Transmission Fluid Pan Leaks

2016 Accord with CVT

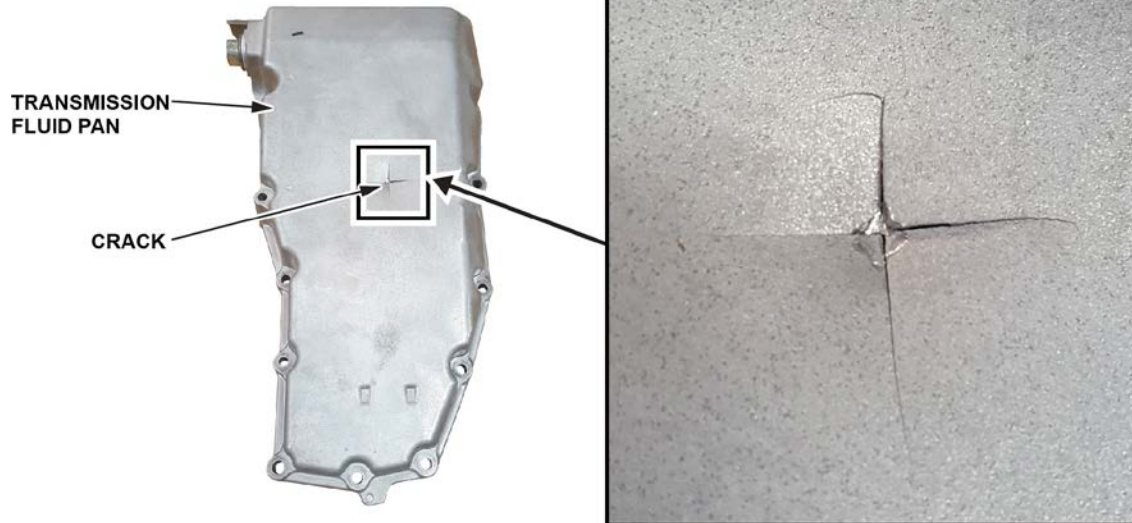
Is the transmission fluid pan leaking from a crack like you see here?

Chances are your customer accidentally ran over something that drove the lower engine cover up into the transmission fluid pan. The cover's front clip, which is made of metal, cracked the pan from the impact.

When replacing the transmission fluid pan, be sure to replace the lower engine cover (P/N 74110-T2F-A01) as well. The replacement lower engine cover eliminates the front hole and clip and replaces the metal clip for the second hole with one made of resin.
